HISTORIC SITE PRESERVATION BOARD STAFF REPORT

DATE: October 8, 2013

SUBJECT: A MINOR ARCHITECTURAL APPLICATION (MAA) AND A CERTIFICATE OF APPROVAL REQUEST BY BANK OF AMERICA TO INSTALL ROOFTOP MECHANICAL SCREENING ON THE CITY NATIONAL BANK BUILDING, A CLASS 1 HISTORIC SITE LOCATED AT 588 SOUTH PALM CANYON DRIVE (PALM CANYON AT CAMINO PAROCELA) ZONE C-1 (CASE 3.0899 MAA / HSPB 52)

VIEW OF EXISTING ROOF CONDITION

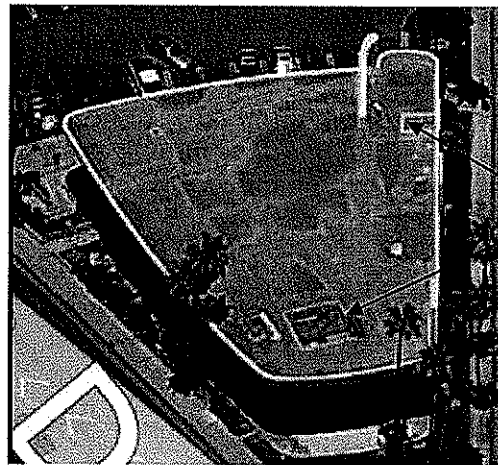
B of A has proposed placement of the new package units generally in the center of the roof of the existing building and screening. The proposed screening is 56 inches above the roof surface and is set in from the perimeter roof edge to be minimally visible from public view.

The proposed rooftop mechanical screen carefully and sensitively integrates with the curvilinear form of the banks facade. It is set back from the roof edge to minimize its visibility from the public streets. It is respectful of the architectural significance of the building and thus conforms to this guideline.

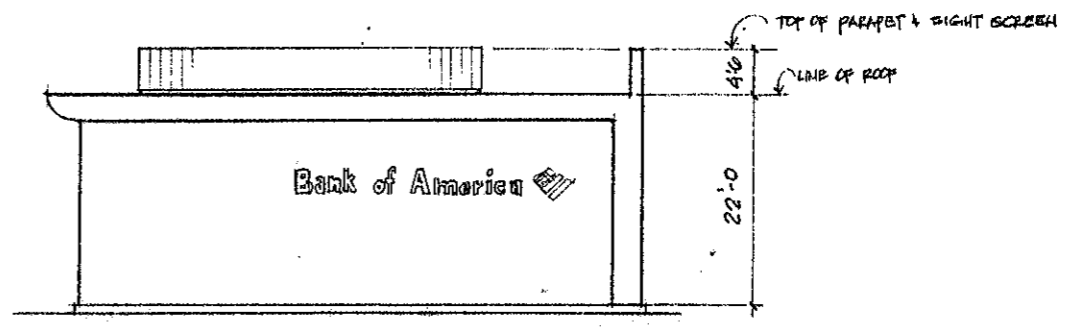
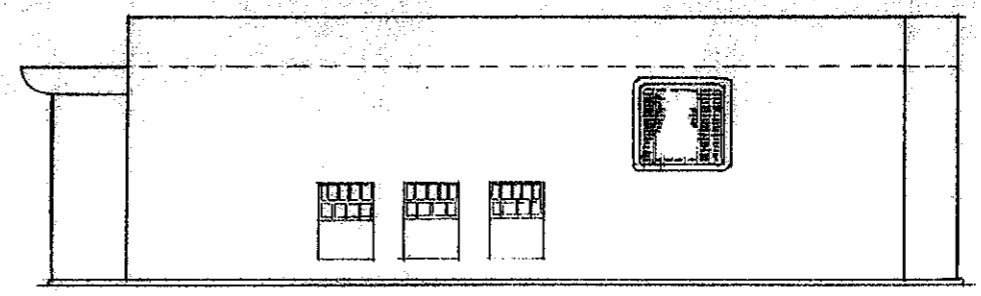
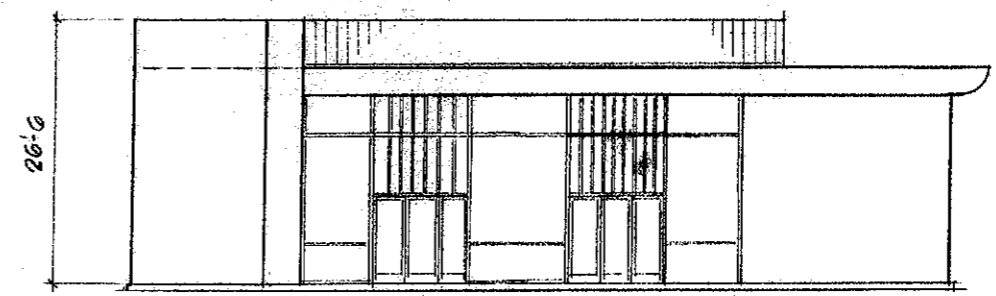
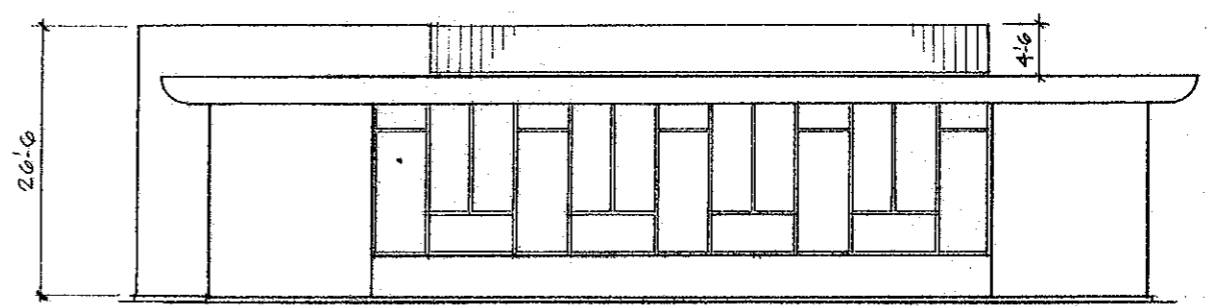
The proposed roof screen is proposed in a neutral color to blend with the cream white color of the roof element of the bank. It relates to the curvilinear west and south façade by following the same curvilinear form. The historic significance and architectural value of the City National Bank building is not impacted by the proposed screenwall and thus the project conforms to this guideline.

The solid metal screen is proposed in an off-white color that is harmonious and compatible with the existing surfaces and materials of the roofline of the bank while not attempting to mimic or replicate adjacent materials or surfaces. It will be slightly higher than the existing parapet roofs and set back from the parapet edge so it is not easily seen from the adjacent streets. It will not detract from the overall historic feeling or significance of the building. The proposed project conforms to this guideline.
